From: Annie Avery
Sent: Friday, August 1, 2025 10:18 AM
To: Miranda Sires
Subject: Raising Canes CUP1-25
Attachments: [Fire Truck Turnaround.pdf](#)

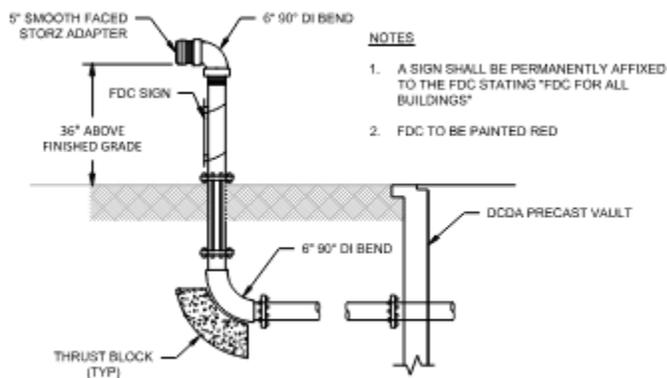
1. Fire Department Connection can't be located on the building.
2. Fire Department connection and Fire Hydrant should be within 25 feet of each other.
3. Fire Department connection must have a 5" storz connection
4. Turning radius included in attachment. Show turning radius for fire truck access.
